NUMBER: 84-9

FUEL PUMP IMPROVEMENT MARINER 20 (U.S. BUILT) MERC 18XD & 25XD

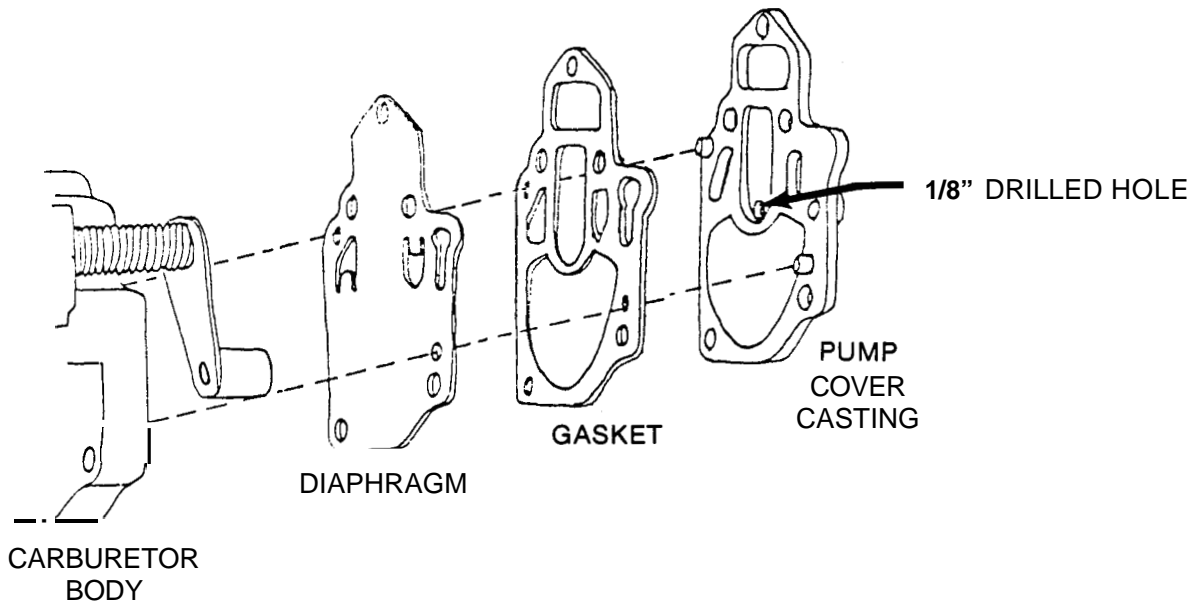
1. Disassemble fuel pump plate from carburetor, discard gasket and black diaphragm.
2. Drill $1/8"$ (.125) hole thru fuel pump cover plate as shown.

THIS VENTS THE BACK OF A PULSE CHAMBER

3. Reassemble with new gasket, and new **thicker** pump diaphragm. The new diaphragm has a greater resistance to falling into the check valve holes.
